**DIVISION OF WATER RIGHTS  
REPORT OF INSPECTION**

**REGISTRATION: D030945**

**STATEMENTS: S015022 & S016375**

Photo 3 – MMR POD on Stanshaw Creek

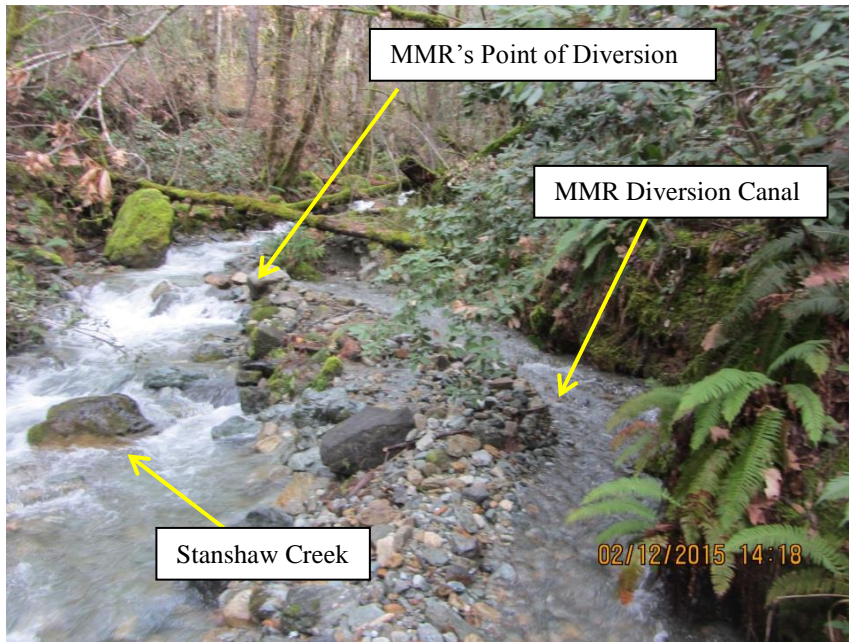
MMR's POD is located approximately three-quarters of a mile upstream of the Highway 96 crossing. The POD is located on United States Forest Service property. The POD consists of a handmade rock wing diversion dam located on the east creek bank of the Stanshaw Creek channel (Photo 3). Water is gravity diverted at the POD and conveyed approximately a half-mile in a partially lined and partially unlined diversion ditch to a juncture where water is routed to the water treatment facility and to the penstock for hydroelectric power generation.

The POD lacks a permanent control structure that would regulate the amount of water diverted from Stanshaw Creek and requires regular maintenance by augmenting the placement of rocks in the stream channel. MMR has constructed two outfall structures located within the diversion ditch downstream from the POD to relieve the diversion ditch from excess amounts of water that would overflow the diversion ditch that has little to no free board space.

During the Division's facility inspections on December 17, 2014 and on February 12, 2015, Division staff observed that the facility's POD intake did not have a control mechanism to manage flow through the open ditch system. Without a control mechanism, such as a diversion gate that has the ability to restrict flow through the POD, water may be diverted in excess of the diversion ditch capacity and in excess of what is reasonably required for beneficial use.

Furthermore, Division staff find that the method of diversion is unreasonable based on the absence of a fish screen at the POD to prevent fish entrainment. MMR's POD intake does not have the ability to prevent fish from becoming entrained. Fish that become entrained in MMR's

1. Install a water diversion control mechanism at the POD. When Stanshaw Creek is under high flow conditions MMR will have the ability to restrict the amount of water entering the diversion ditch, limiting the risk of ditch failures and diverted water from overtopping the diversion ditch. When flow in Stanshaw Creek is insufficient to meet all of MMR's consumptive water demands, a control structure will limit the amount of water diverted to an amount that can be beneficially used. Provide a time schedule for installation of a water diversion control mechanism at your POD and photographic evidence that documents installation of the control mechanism, to be reviewed by the Division. MMR may need to consult with the Regional Water Quality Control Board concerning a 401 Certification Permit and DFW regarding a 1600 Lake and Streambed Alteration Permit to install a water diversion control mechanism.

5. Immediately implement the NMFS and DFW by-pass flows and cease impacts to public trust resources and habitat.
6. The Coles must consult with CDFW to determine whether a fish screen to prevent fish entrainment should be installed or whether an alternative method or POD design could be modified to prevent fish entrainment.

Photo 5 – Second outfall structure in diversion ditch.

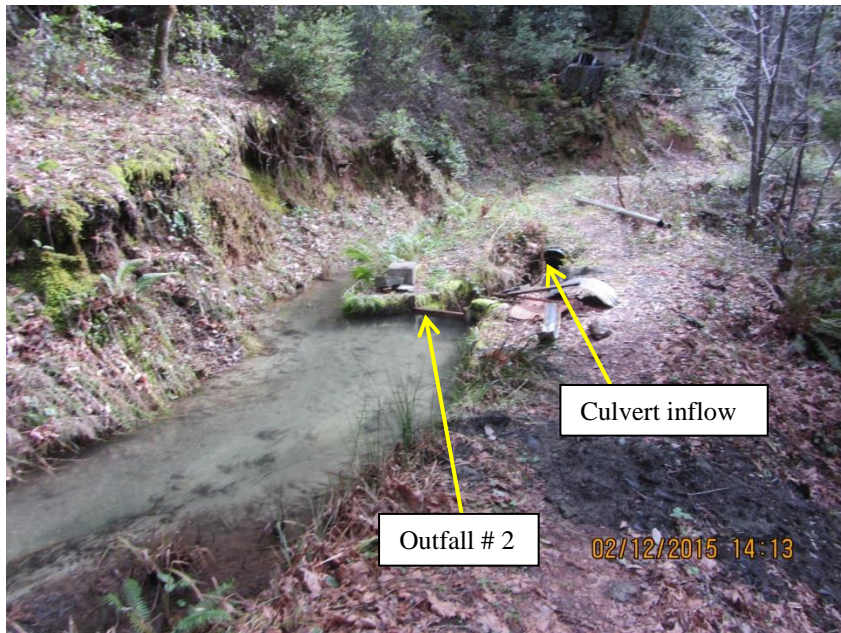
The excess water from the two outfalls discharges water back to Stanshaw Creek. The first of two outfall structures is located approximately 50-feet downstream of the POD (Photo 4). The first outfall structure is operated in a similar manner as the POD and requires regular augmentation flash board risers and rocks in the diversion ditch to manipulate the amount of water conveyed by the diversion ditch. The second outfall structure is located approximately 300-feet downstream of the POD and occurs just before the diversion ditch narrows from approximately 60 inches in width to approximately 30 inches in width (Photo 5). Flash boards are used in the second outflow structure to manipulate the amount of excess water discharged from the diversion ditch. Water from the second outfall structure is discharged via a shotgunned culvert into a small unnamed tributary to Stanshaw Creek, then to Stanshaw Creek. The culvert appears to have caused a large erosion feature in the downslope channel (Photo 6 & 7).

Photo 21 – Aerial photo identifying locations where flow velocity was recorded.

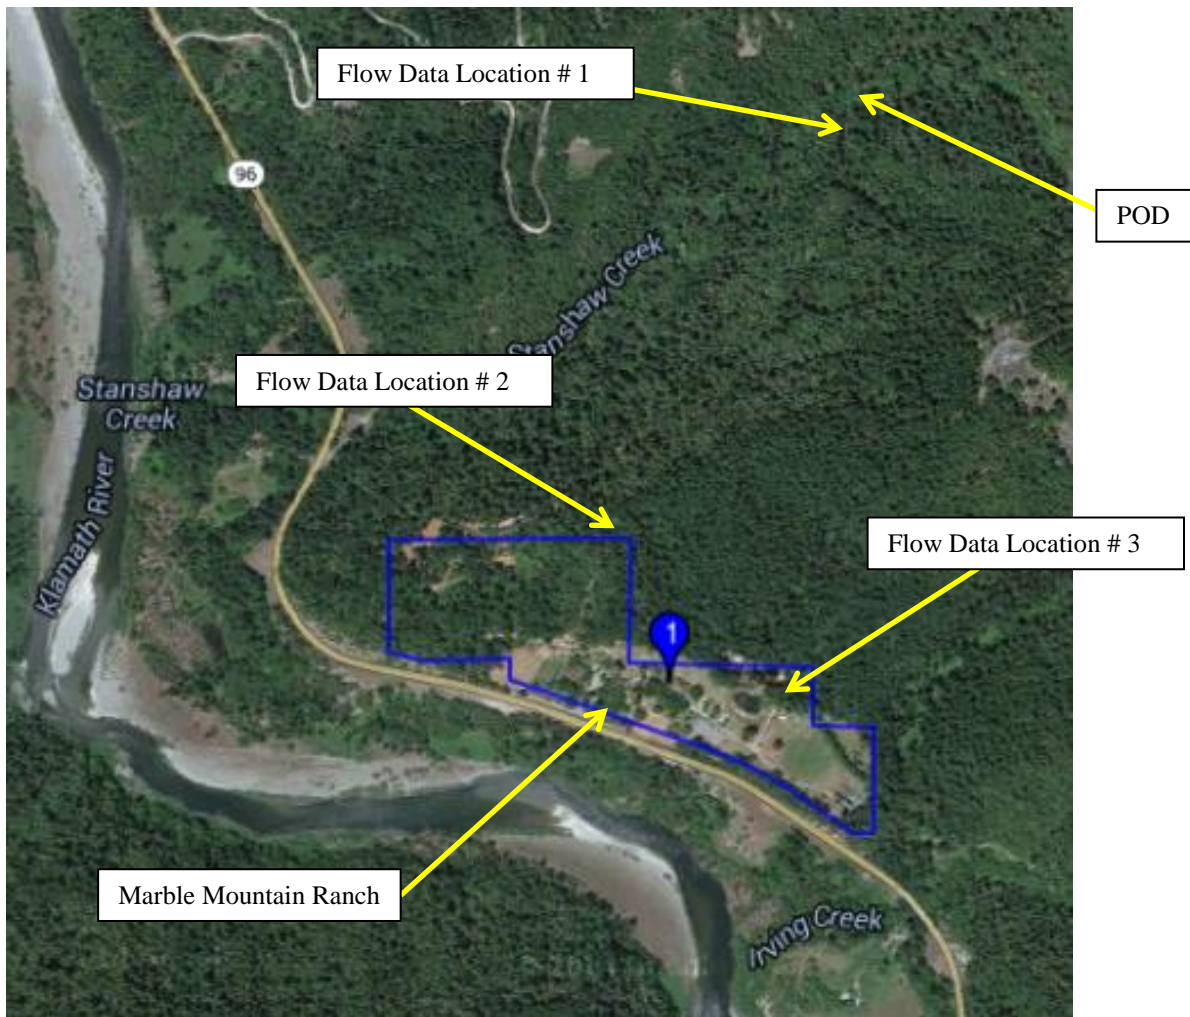
During the February 12, 2014 inspection Division staff, Skyler Anderson took three flow measurements at three locations within MMR's diversion ditch: 1) in the diversion ditch

approximately 50-feet below the POD on Stanshaw Creek and below the first outfall structure; 2) in the diversion ditch approximately 100-feet downstream of the 2” domestic water line intake; and 3) in the diversion ditch below the recreational pond and before flow is discharged to Irving Creek (Photo 20). Division staff estimates the ditch capacity is approximately 3-4 cfs. When the ditch is flowing at capacity Flow data and latitude and longitude coordinates for the data collections are summarized below in Table 1.

Location # 1 is located within the MMR’s diversion ditch just below the POD on Stanshaw Creek and Division staff, Skyler Anderson recorded a flow rate 2.23 cfs. Location # 2 is located within the diversion ditch 100-feet downstream of the 2-inch domestic water line intake and approximately 50-feet upstream of the terminus into the penstock. Division staff, Skyler Anderson recorded a rate of flow of 1.63 cfs at Location # 2. Division staff, Skyler Anderson calculated a ditch loss of approximately 0.6 cfs by subtracting the flow taken at Location # 2 from Location # 1. The rate of flow at Location # 3 was measured at 1.23 cfs and is located within the diversion ditch just below the pond. Flow was recorded at this location to determine the MMR’s consumptive water demand for domestic and irrigation uses. MMR’s domestic and irrigation water demand was calculated by subtracting Location #3 from Location # 2. At the time of the inspection, MMR’s domestic and irrigation demand is approximately 0.4 cfs.
